ADDRESSEES	: Owners and operators of coaches listed under “Application” ABC Customer Care and Parts Source
VEHICLE MODEL	: CX35 MY2020, CX45 MY2020
MANUAL SECTION	: 08.02 Climate control – control system
BULLETIN TYPE	: Field Change Program
DATE	: January 26th, 2022
SUBJECT	: Optimization of driver’s cab climate control system operation
TERMS & CONDITIONS	: Refer to the warranty section further in this Bulletin.

- Van Hool have received some complaints about the temperature control in the driver’s cab. Investigation has shown that these vehicles have left the factory with a driver’s cab climate control unit outlet temperature sensor that is not compatible with the dash control unit.
- To address this issue, Van Hool is conducting a Field Change Program at which the original temperature sensor will be disconnected, and a new one will be installed. The terms and conditions of this Field Change Program are explained further on under “Warranty”.
- Owners and operators of the affected units should follow the procedure below to install the new outlet temperature sensor.
- From VIN 81504 (CX45) and 83025 (CX35) onwards, the vehicles are factory equipped with the new temperature sensor.

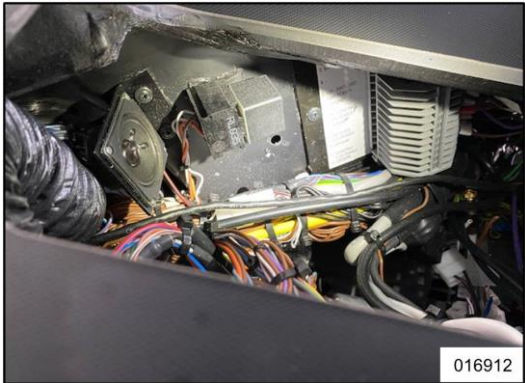
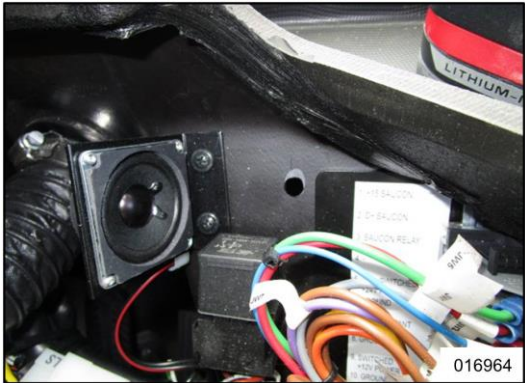
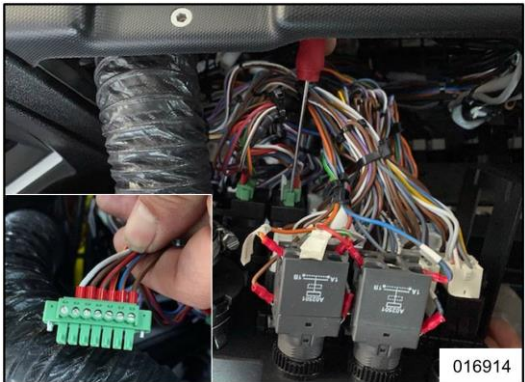
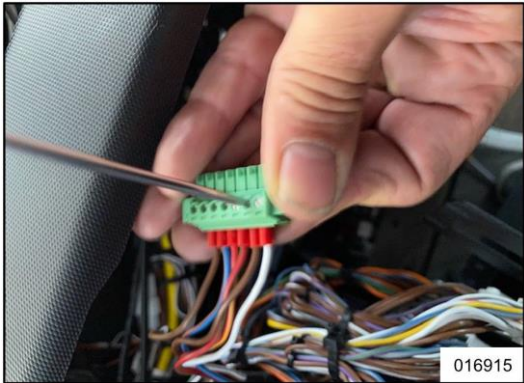
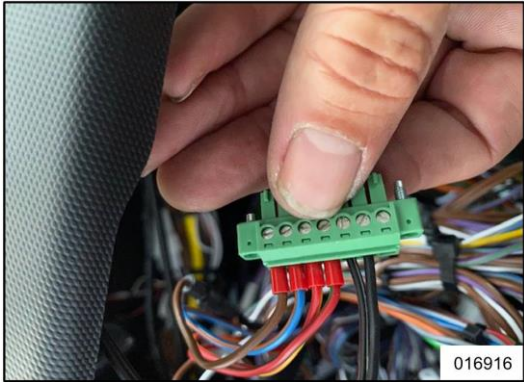
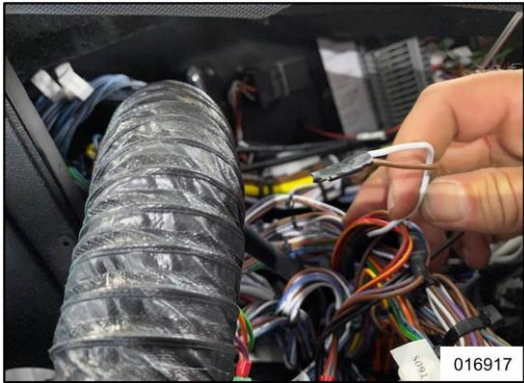
Step	Action
1	Remove the dashboard cover panel.  015958 Figure 2
2	Undo and remove the Torx screws securing the RH dash panel indicated in the figure. Tilt the panel forwards so gain access to the wiring located behind.  015959 Figure 3

3	Drill a 8 mm (21/64") hole in the air duct. Refer to the figures below for the location of the hole.  016912 Figure 4  016964 Figure 5
4	Install the new sensor into the air duct.  016913 Figure 6
5	Remove the connector of the temperature control potentiometer.  016914 Figure 7

6	Remove the wiring of original temperature sensor (white and brown wire, connected at position 5 and 6).  016915 Figure 8
7	Connect the two wires of the new sensor to the connector (position 5 and 6).  016916 Figure 9
8	Cut and isolate the wire ends of the original sensor with some tape.  016917 Figure 10
9	Re-install the dash panels in reverse order of removal.
10	Notify ABC Companies by mail. Write the text "SB1847 completed for VIN....." in the mail and send the mail to warranty@abc-companies.com.
11	For ABC Companies only: register through the registration button located behind Service Bulletin SB1847 on the Van Hool customer portal. Write the text "SB1847 completed" in the field "Remark". Labor allowance will only be awarded after Van Hool has received the registration.
